Well Name: JRU APACHE U FEDERAL COM	Well Location: T22S / R30E / SEC 13 / NESE / 32.39152 / -103.828592	County or Parish/State: EDDY / NM
Well Number: 706H	Type of Well: OIL WELL	Allottee or Tribe Name:
Lease Number: NMNM89051	Unit or CA Name:	Unit or CA Number:
US Well Number:	Operator: XTO PERMIAN OPERATING LLC

Sundry ID: 2839933

Type of Submission: Notice of Intent	Type of Action: APD Change
Date Sundry Submitted: 03/04/2025	Time Sundry Submitted: 01:22
Date proposed operation will begin: 03/07/2025

Procedure Description: XTO Permian Operating, LLC. respectfully requests approval to make the following changes to the approved APD. Changes to include SHL, KOP, FTP, LTP, BHL, casing design, cement program, mud circulation system, proposed total depth and formation (Pool). FROM: TO: SHL: 2427' FSL & 929' FEL OF SECTION 13-T22S-R30E 2456' FSL & 869' FEL OF SECTION 13-T22S-R30E KOP: 2427' FSL & 929' FEL OF SECTION 13-T22S-R30E 2624' FSL & 330' FEL OF SECTION 13-T22S-R30E FTP: 1650' FSL & 330' FEL OF SECTION 13-T22S-R30E 2624' FSL & 330' FEL OF SECTION 13-T22S-R30E LTP: 1650' FSL & 100' FWL OF SECTION 14-T22S-R30E 2624' FSL & 100' FWL OF SECTION 14-T22S-R30E BHL: 1650' FSL & 50' FWL

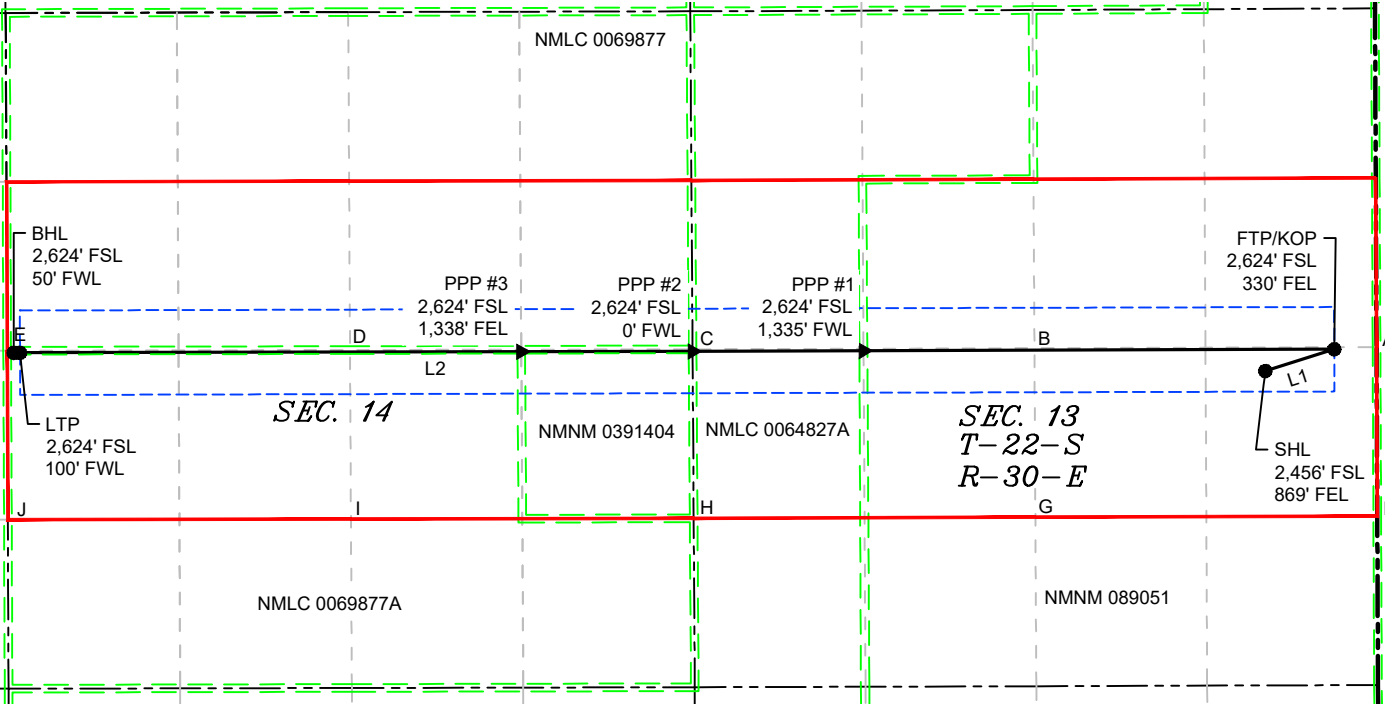
The formation (Pool) is changing from Bone Spring (Los Medanos; Bone Spring) to Wolfcamp (Los Medanos; Wolfcamp, North (Gas) and Los Medanos; Wolfcamp (Gas)). Individual c102s for each pool highlighting the corresponding dedicated acreage are attached.

[Figure F] 4 String – 2nd Intermediate casing engineered weak point

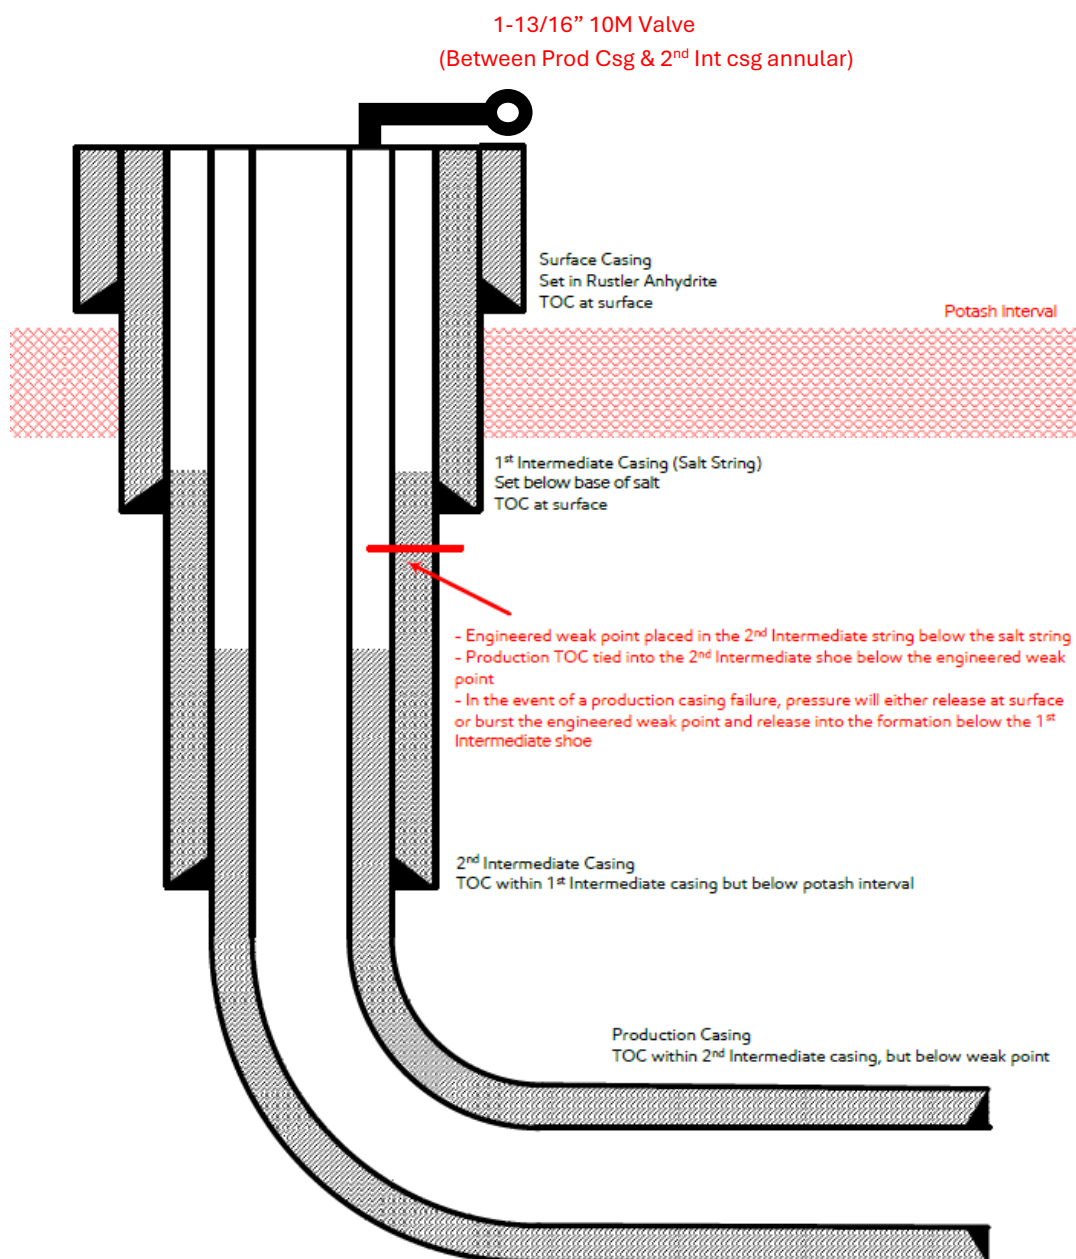
- 1) Alignment with KPLA requirements per schematic below, with engineering weak point casing design and utilizing new casing that meets API standards.
- 2) Contingency plans in place to divert fluids away from salt interval in event of production casing failure.
- 3) Intermediate 2 casing will consist of a primary cement job with TOC at the top of the Brushy Canyon formation within the Delaware Mountain Group.
 - a. Bradenhead squeeze to be completed after primary cement job to tie back TOC to intermediate 1 "Salt string" & below Marker Bed 126 "Potash Interval".
- 4) Production cement to be tied back no less than 500' inside previous casing shoe (intermediate 2 casing) and below the engineered weak point.
